Addendum #02 for RFB #915800-01

Project Name: Grimes Switchgear Replacement

DAS RFB #: 915800-01 DAS Project #: 9158.00

Addendum #2:

Revision ADDENDUM #2 06/25/2020 Drawing Name: **ELECTRICAL GENERAL** NOTES, ONE-LINE, AND SCHEDULES

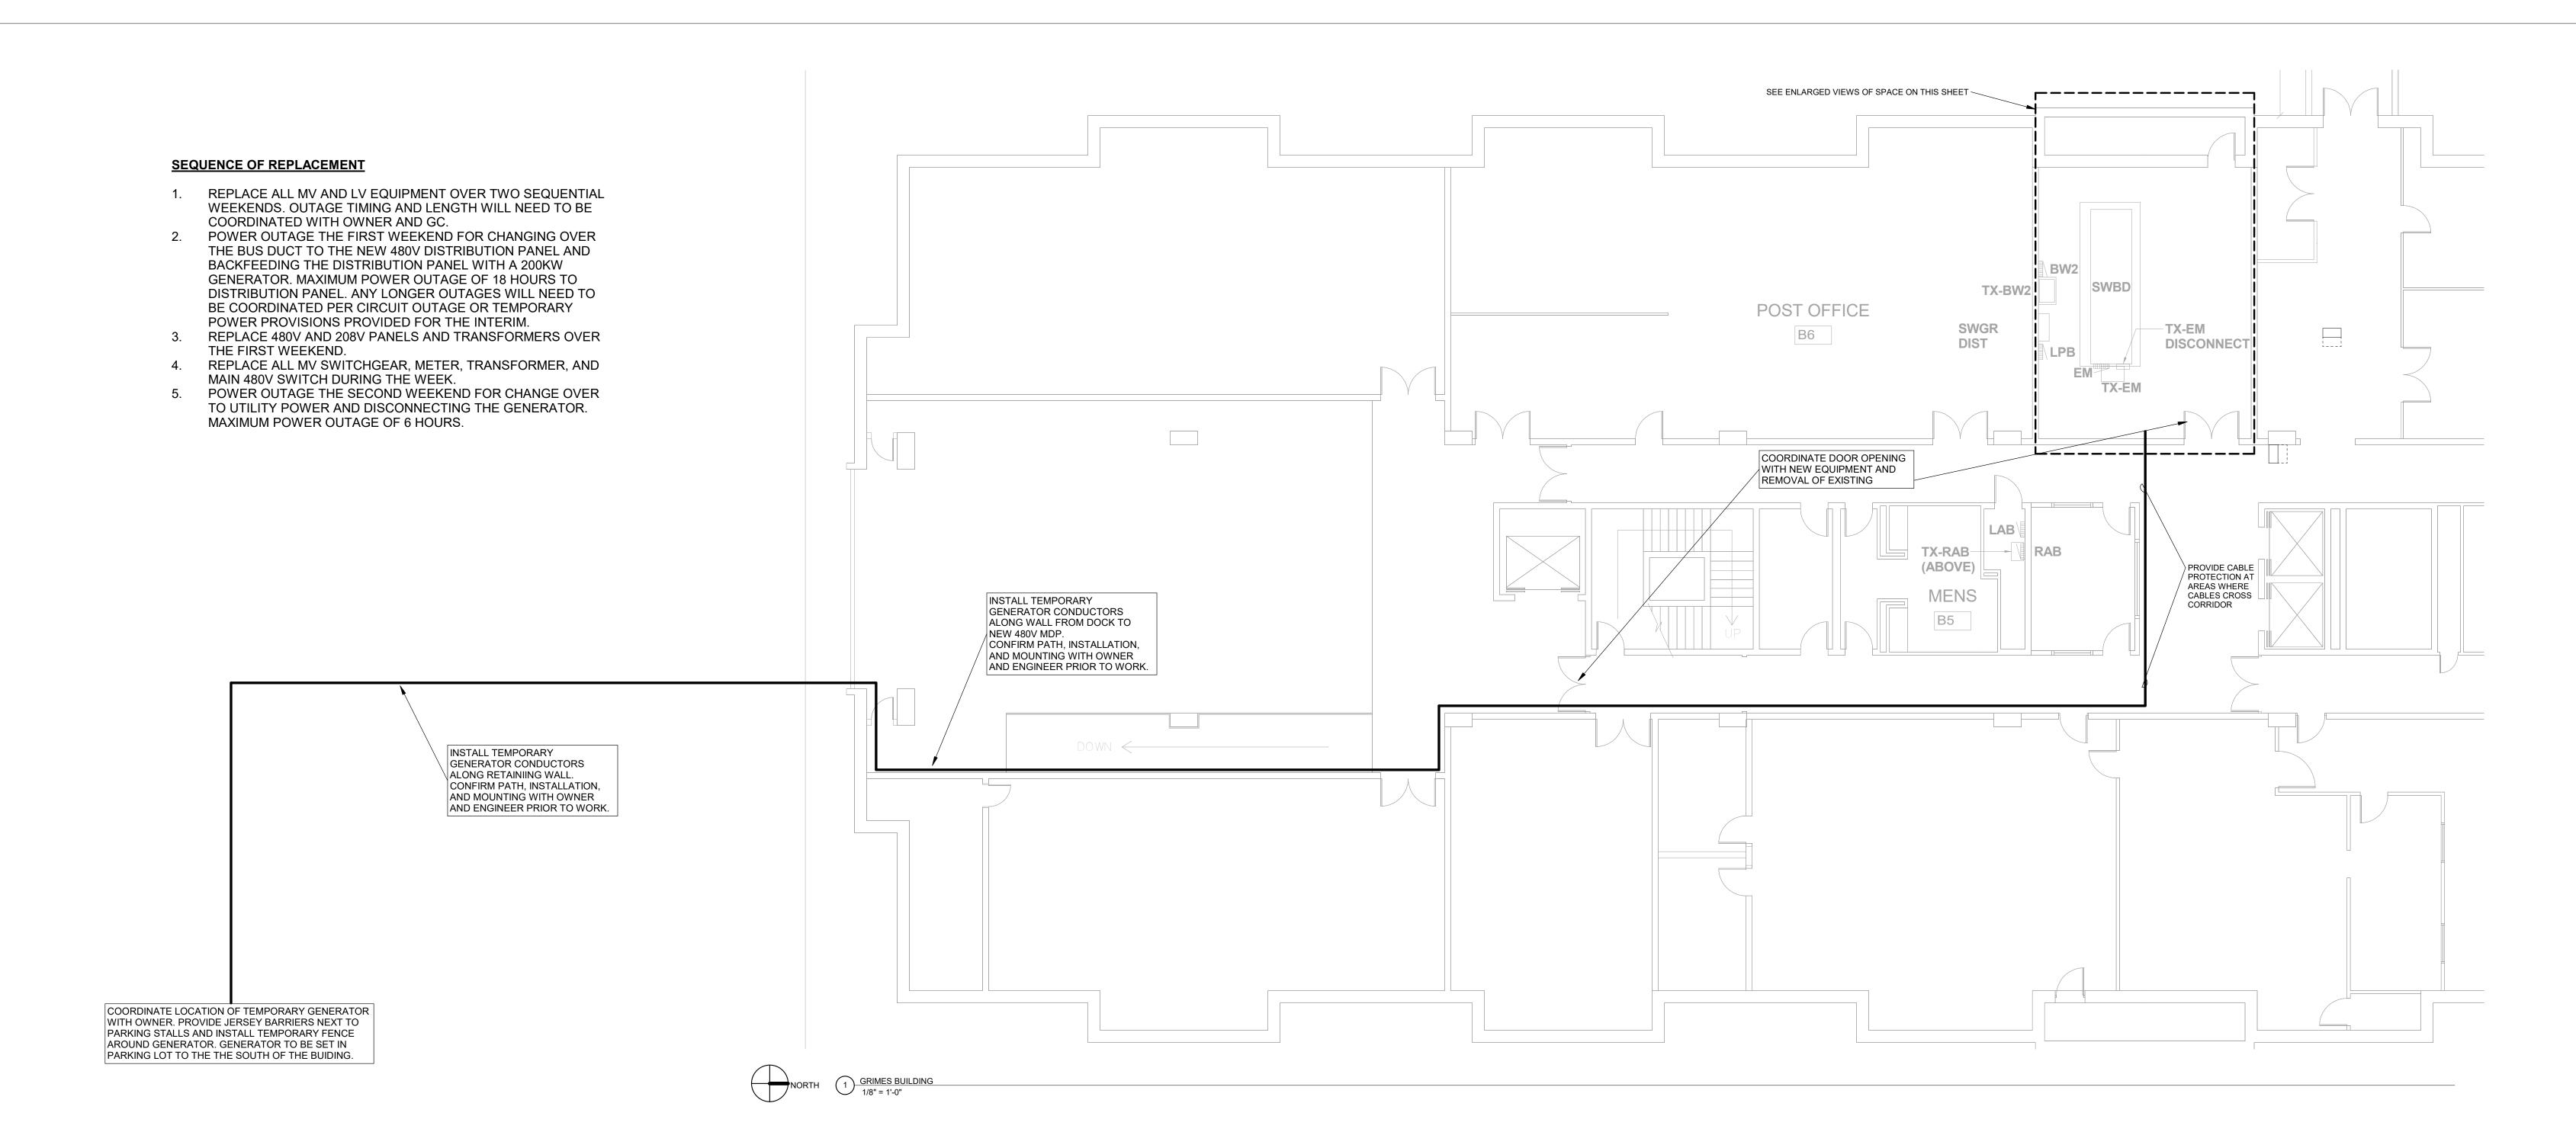
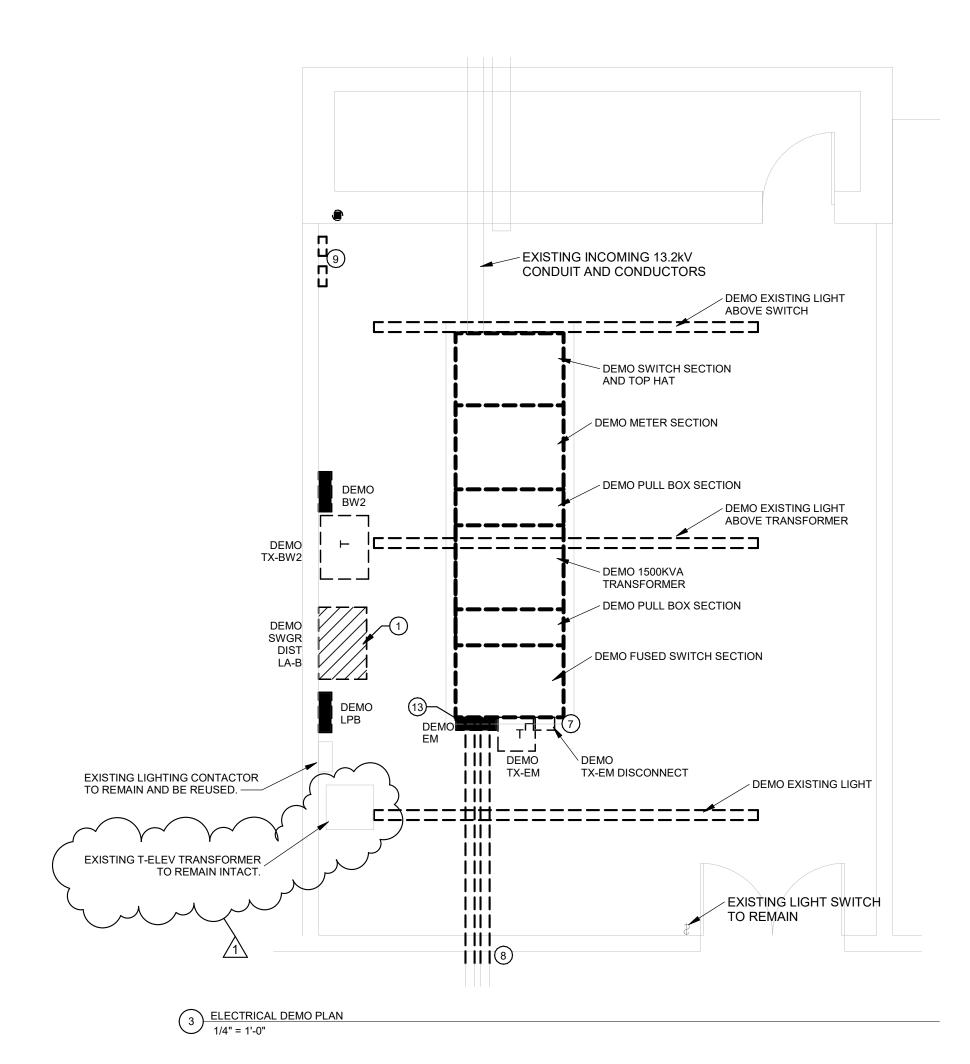
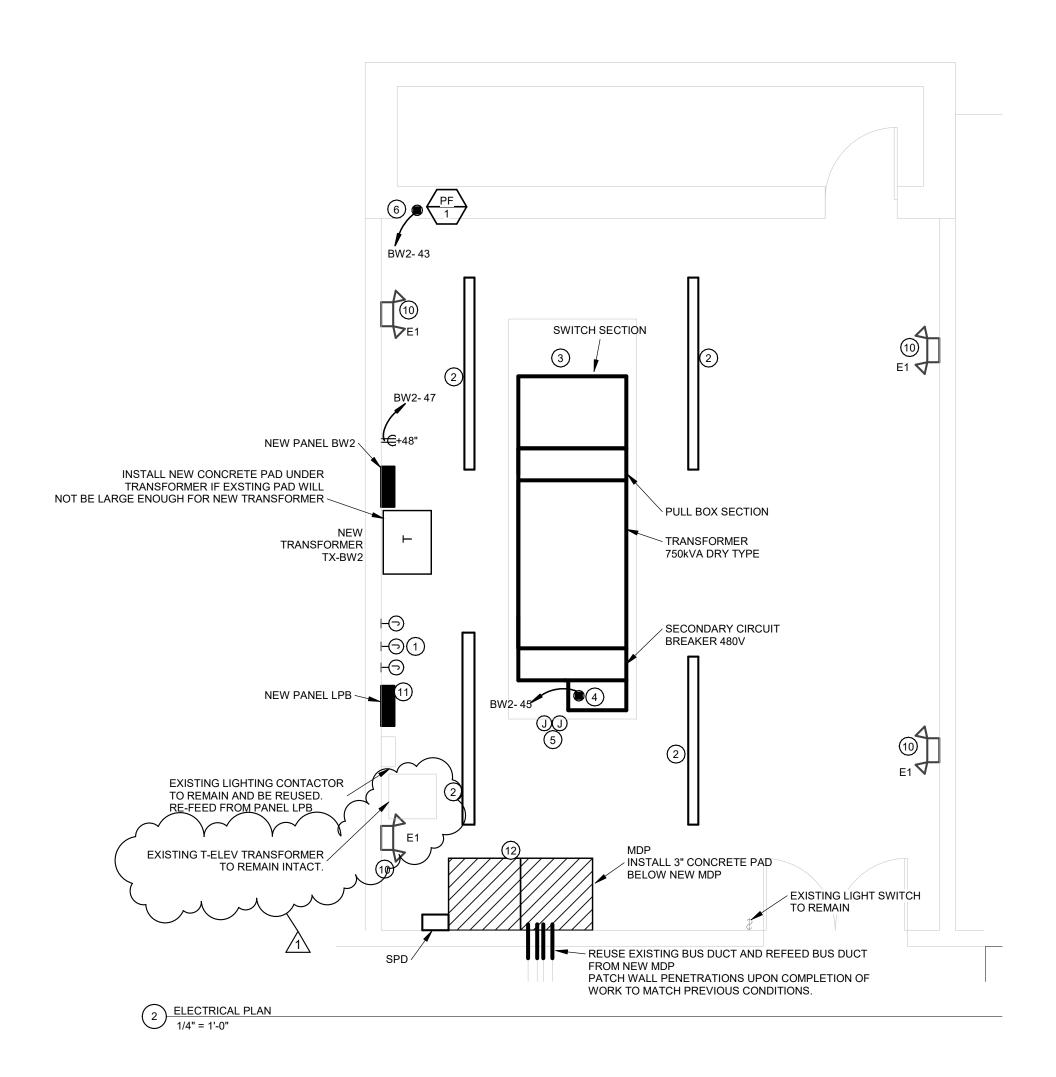
1. There is a new transformer located in the SE corner of the switchgear electrical room. This transformer serves the elevators. Reference updated sheets E1 and E2 for

- Drawing E1- ELECTRICAL GENERAL NOTES, ONE-LNE, AND SCHEDULES
 - a. Clarify existing 15kVA transformer shown on Demo and New one-line Diagram
 - b. Add breaker in panel LPB to match existing breaker feeding 15kVA transformer.
 - c. Refer to attached full size sheet E1.
- 2. Drawing E2-Grimes Electrical Plan
 - a. Clarify location of existing 15kVA transformer in electrical room.
 - b. Refer to attached full size sheet E2.
- 3. Drawing M1 Mechanical Plan
 - a. Revise Keynote 1. Fan model changed to Greenheck Model AER-E206-620-B3.
 - b. **ADD** a note to Detail 3/M1 Propeller Exhaust Fan Detail about providing a flanged frame around the existing opening as required.
 - c. Refer to attached full size sheet M1.

Drawing Name: MECHANICAL PLAN

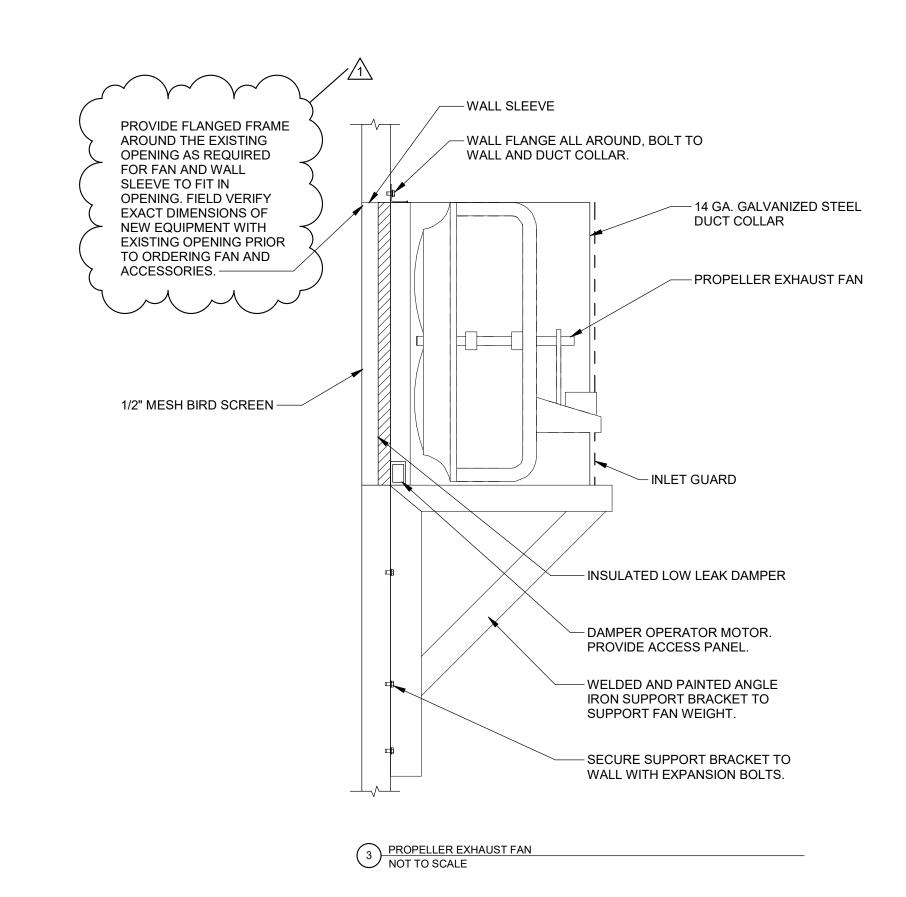
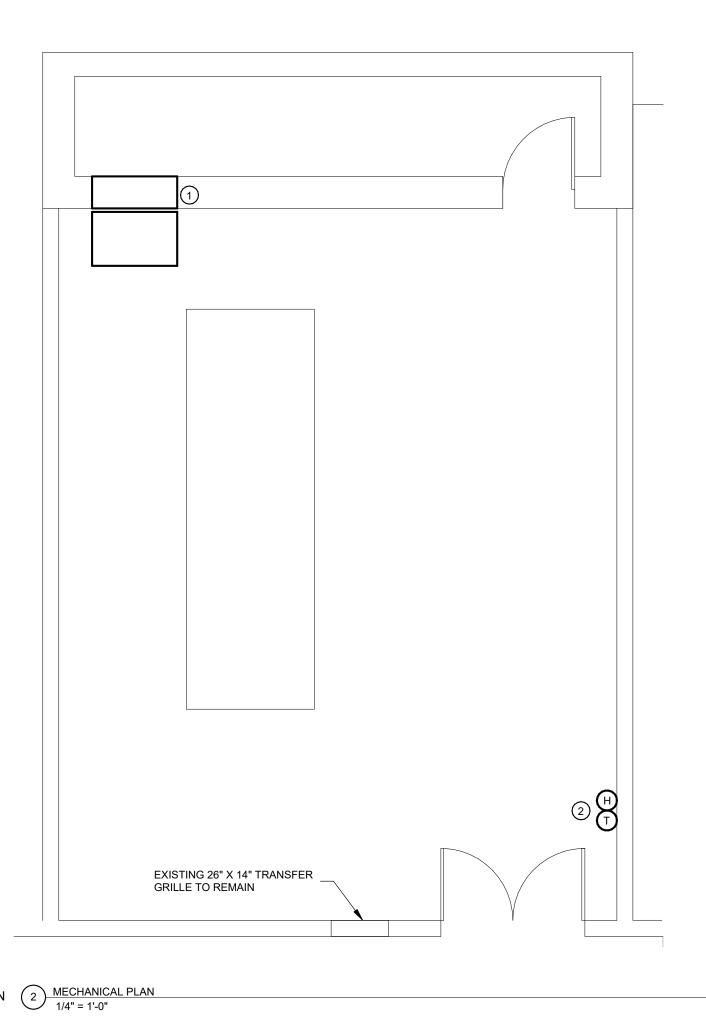
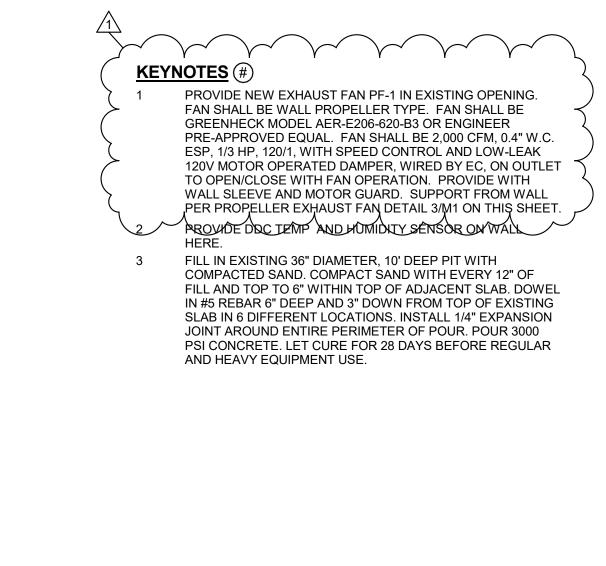
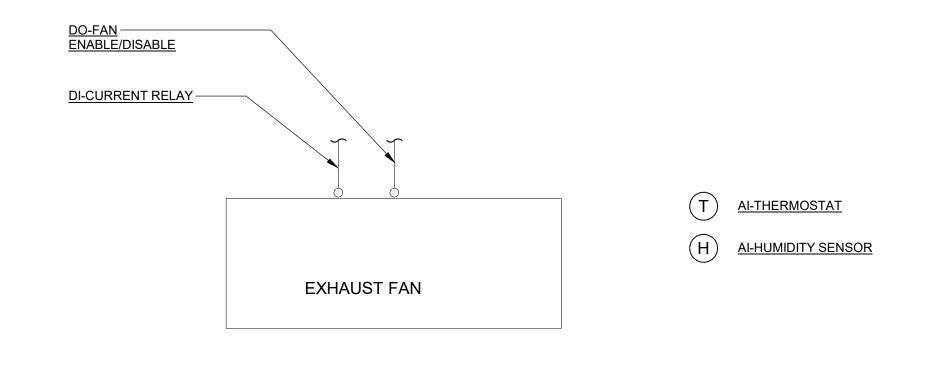
- **Q1**. Concerning the generator cables temporarily installed inside the garage and hallways, are these to be sleeved in conduit for added protection, or is normal care in layout sufficient?
 - **A1**. The cables do not need to be in conduit. The contractor is responsible to protect temporary cables from damage and ensure the placement is safe for building occupants.
- **Q2**. Is it the intent to completely fill with concrete, or could a base of fill type material be used first and then topped with concrete?
 - **A2**. Please reference keynote 3 on sheet M1. The pit is to be filled with compacted sand and topped with 6" of concrete.
